# **Official Transcript of Proceedings**

Title: Advisory Committee on Reactor Safeguards  
Power Uprates Subcommittee - Open Session

Date: June 22, 2012

POWER UPRATES SUBCOMMITTEE

# LEFM ✓ + System Overview

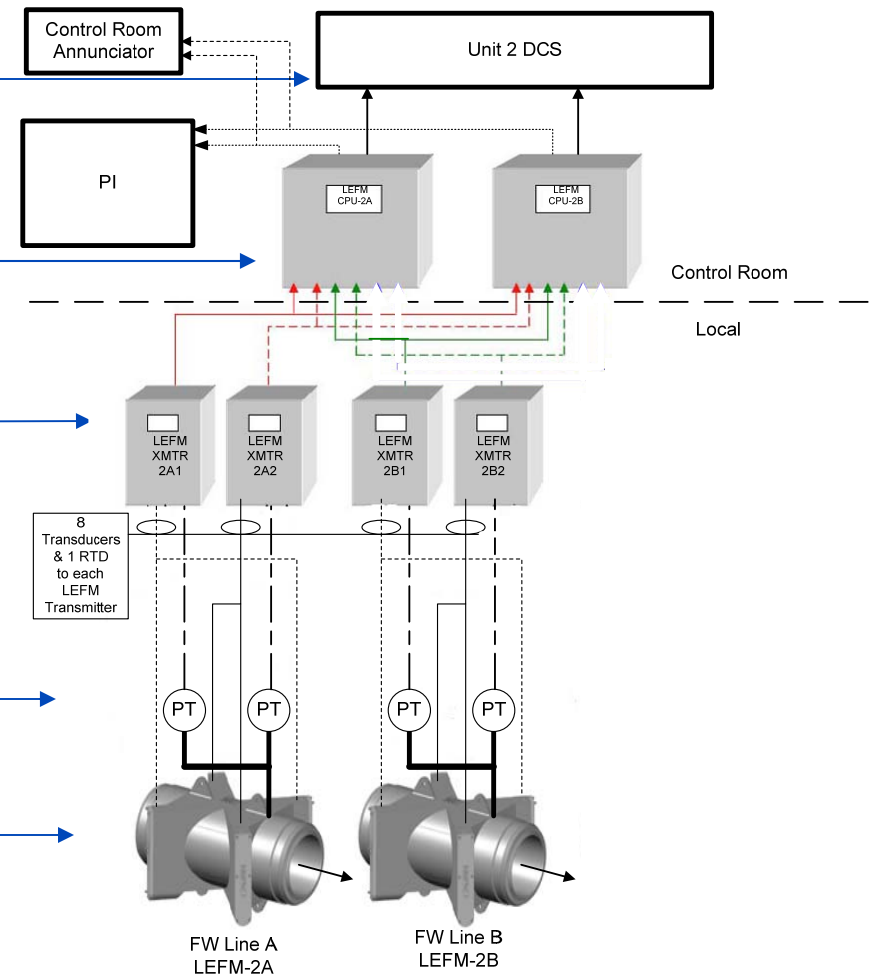
5 MEMBER BROWN: These PI system  
6 communication links will provide the same high level  
7 data to the DCS, the DCS as well as LEFM performance  
8 and diagnostics, you know, for performance monitoring.  
9 I guess my question is okay, now it's in the DCS. Is  
10 it -- at some point, does the DCS communicate with the  
11 outside world via, because you talk about Ethernet  
12 connections throughout those discussions.

19 MEMBER BROWN: So in the absence of  
20 diagrams and some architectural representation of  
21 where this information goes to, it gives the clear  
22 impression it just disappears out of the plant and  
23 gets siphoned off via some Ethernet connection to  
24 outside world, the Internet, corporate world,  
25 whatever.

1           There was no mention, relative to the  
2           cybersecurity, what type of reg guides or what  
3           interfaces govern, for instance, RG 5.71, which lays  
4           out a level of isolation for critical plant data,  
5           which this is. It also leaves open the question about  
6           whether somebody could get in and modify that data as  
7           it is being presented to the operators, if you've got  
8           an Ethernet connection coming into the DCS.

9           So I don't know how you're going to  
10          explain all that in this particular meeting, but I did  
11          want to make you aware that somewhere along the line,  
12          I would like to get a clear understanding of why  
13          nobody is ever going to be able to get in. RG 5.71  
14          makes it fairly clear that if you're going to  
15          communicate outside the main plant, it should be a one  
16          way only communication link.

9 MEMBER BROWN: Or whether it has access,  
10 people can actually access it and tell the PI system  
11 to do things or provide information to them. Because  
12 if you're connecting with that via the Ethernet system  
13 as well, then you're just daisy-chaining the dual bi-  
14 directional communications all the way into the plant.

4 MR. HOFFMAN: Yeah. Let me just add on to  
5 what Steve has said. Several years back, going from  
6 analog to digital technology, we implemented a  
7 distributed control system is what we call it or DCS  
8 in the control room, that provides the operator --  
9 there's a number of different systems that communicate  
10 with the Distributed Control System in the control  
11 room, to provide operators with much better  
12 information, touch screens and what-not, and that is  
13 isolated from the outside world.

14 That is a system that is specific and does  
15 not communicate outside the control room. The way we  
16 implemented the Leading Edge Flow Meter modification  
17 is we simply, using the DCS as the what I'll call the  
18 brains to do the calorimetric calculation, the outputs  
19 of the LEFM provides the inputs into the DCS to do the  
20 calorimetric calculation.

21 The calorimetric information is displayed  
22 in the control room. The calculated calorimetric  
23 information is displayed in the control room, and  
24 that's not communicated with the outside. That  
25 information, correct me if I'm wrong Todd, is used by
